**TO: ALL VOLVO RETAILERS - US & CANADA**  
**RE: RECALL CAMPAIGN 128**

<b>VOLVO</b>				TITLE:		GROUP:	NO:	
				Recall Campaign 128		23	128	
<b>Service Manager Bulletin</b>				Fuel Rail S40/V40 mdl. Yr: 2003/ 2004		ISSUING DEPARTMENT: <b>Warranty</b>		
				REFERENCE BULLETINS: PB 23-128 SB 23-0083		CARMARKET: <b>North America</b>		
Service Person- nel: read and initial.	SERVICE MANAGER	SERVICE WRITER	WARRANTY ADMINISTRATOR	DATE:		YEAR	MONTH	DAY
				2004		01	13	
<b>Page 1 of 3</b>

## Recall Campaign No. 128 — Fuel Rail

### Check fuel rail and install clamp

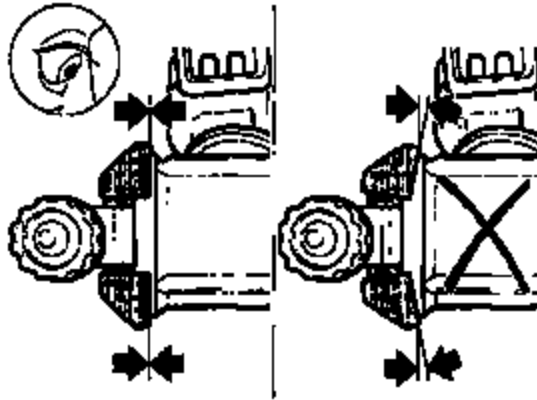
Check the mounting of the service nipple on the fuel rail. Visually check the mounting of the end cover.

The end cover must be in line with the end of the fuel rail as illustrated.

If the end cover is in line with the fuel pipe; Continue with step 2.

If end cover is not in line with the fuel rail, replace the fuel rail. See VADIS:

#### Install the additional clamp

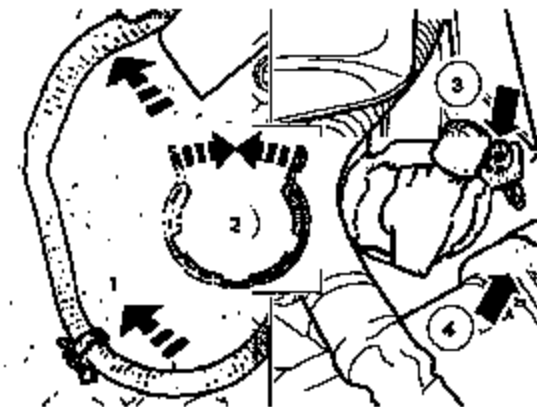
Slide the cable harness through the clip (1) to the rear for better access.

Press the new clamp together. Position the lips of the clamp together by bending (2).

Place the clamp (3), with the broad side, towards the service nipple, over the connection. See illustration.

Position the clamp (note the opening for the extra rib) as illustrated.

Apply thread locking compound (Loctite) on the screw before fitting. Install the torx screw (T25) . Tighten to 3 Nm.

**Caution:** Ensure that the screw does not come in contact with the radiator hose or hose clamp (4).
